M. Smyth Comments on Flood Risk Assessment information relative to appeal
APP/R3650/W/25/3367393

The Appellant has provided two documents relative to Appeal APP/R3650/W/25/3367393, Appeal reference A for Pitch 1 at Lydia Park.

The figure shows the suggested timeline for the model review process.

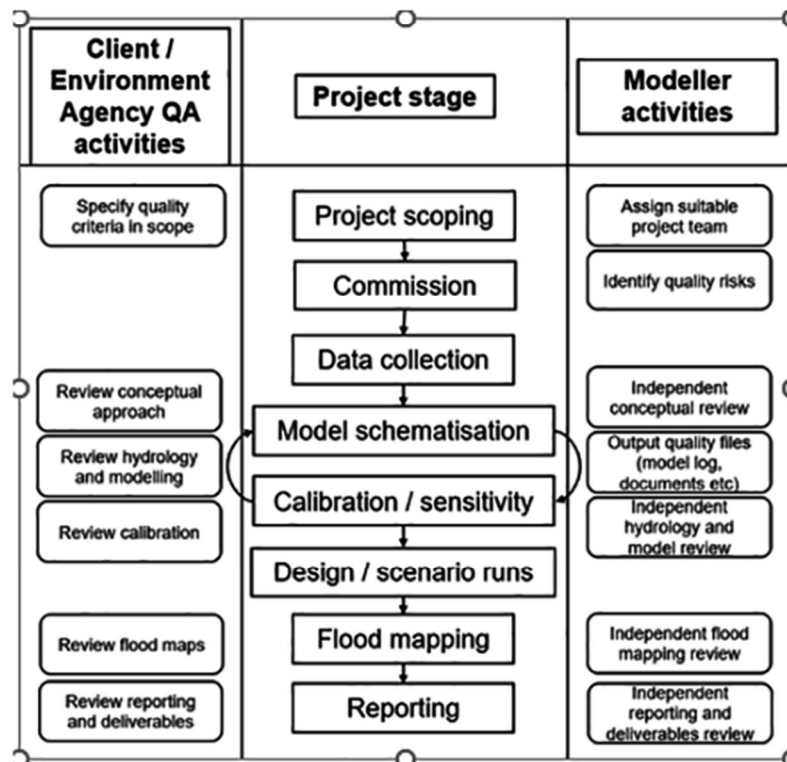
SEPA (2016) includes a suggested timeline for the model review process. This activity closely follows the EA process.

The suggested timeline for flood modelling is set out, and due to the complexities and scope for error to influence the modelling result. The typical timeline for a review of a site-specific hydraulic model is usually in the order of 3-4 months, or potentially longer for more complex or unstable hydraulic models.
